ADDENDUM NO. FOUR
THORNTON WATER PROJECT
SOURCE WATER PUMP STATION
PROJECT NO. 12-777XP
CITY OF THORNTON, CO

DATE: July 16, 2026

PURPOSE: To provide additional information and clarification to the solicitation documents for the above-referenced Project.

50C03

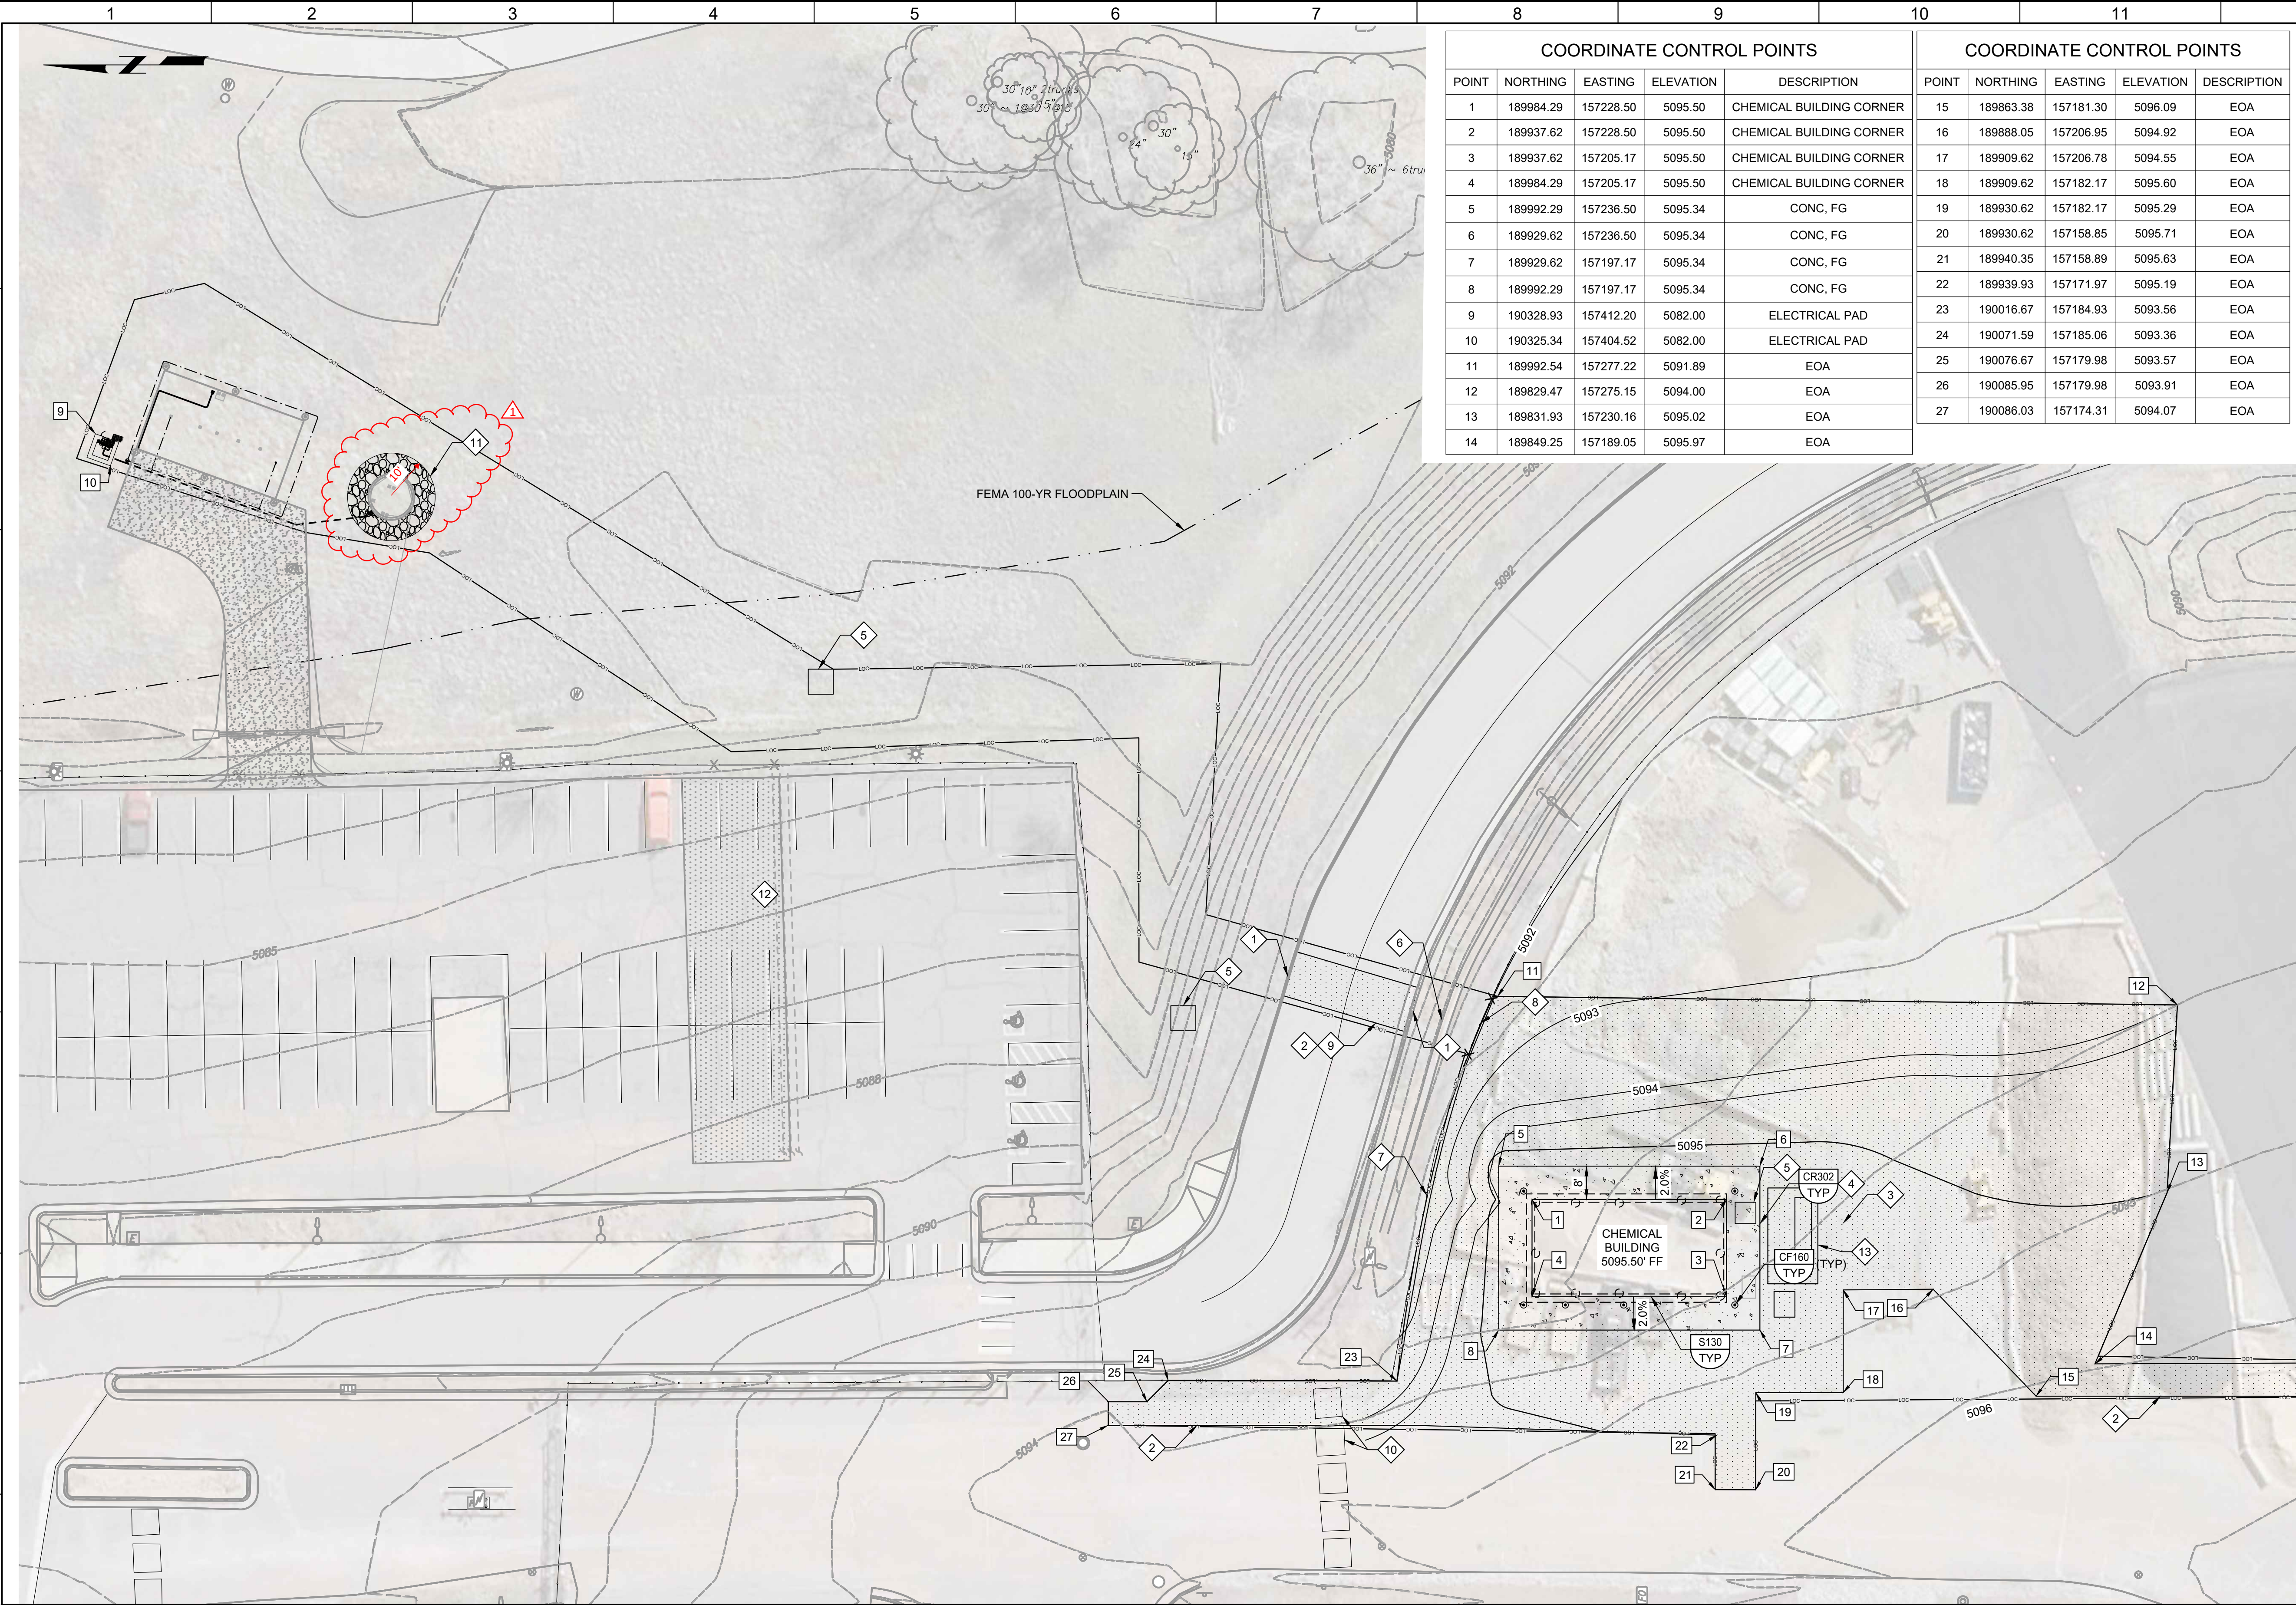
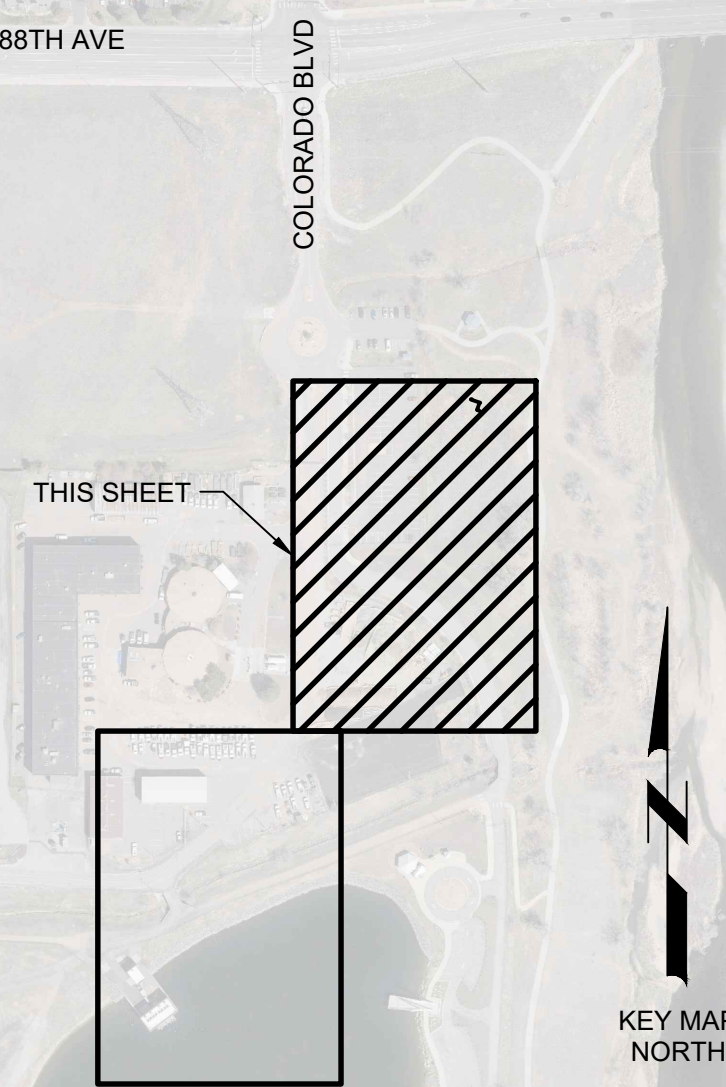
- 1. The following drawings are deleted in their entirety and replaced with the revised drawings: 50C01, 50C03, 50S06: (under separate cover).

- INSTALL CURB AND GUTTER TO MATCH EXISTING CONDITION, INSTALL TO EXISTING LINE AND GRADE.
- INSTALL ASPHALT PAVING TO MATCH EXISTING SECTION + 1", INSTALL TO EXISTING LINE AND GRADE.
- 4" ASPHALT PAVEMENT OVER 8" OF CLASS 6 BASE COURSE.
- 8" WIDE CONCRETE APRON.
- ELECTRICAL HANDHOLE, SEE ELECTRICAL PLANS.
- INSTALL 6" THICK CONCRETE CHANNEL TO EXISTING LINE AND GRADE.
- INSTALL 2' ASPHALT CURB CUT, OUTLET ROOF DRAIN TO CONCRETE CHANNEL.
- INSTALL 6" CHAIN LINK FENCE.
- RESTORE EXISTING PAVEMENT MARKINGS.
- INSTALL TYPE 1 SPEED CUSHION AND PAVEMENT MARKINGS PER CITY OF THORNTON DETAILS AND DRAWING NO. 500-21.
- REMOVE 6-INCHES OF EXISTING MATERIAL AND REPLACE WITH 6-INCHES OF ABC IN A 10-FOOT DIAMETER RADIUS AROUND THE EXISTING CHEMICAL INJECTION MANHOLE.
- PARKING LOT CAN BE USED TO STOCKPILE MATERIAL.
- GENERATOR PAD. SEE STRUCTURAL FOR DETAILS.
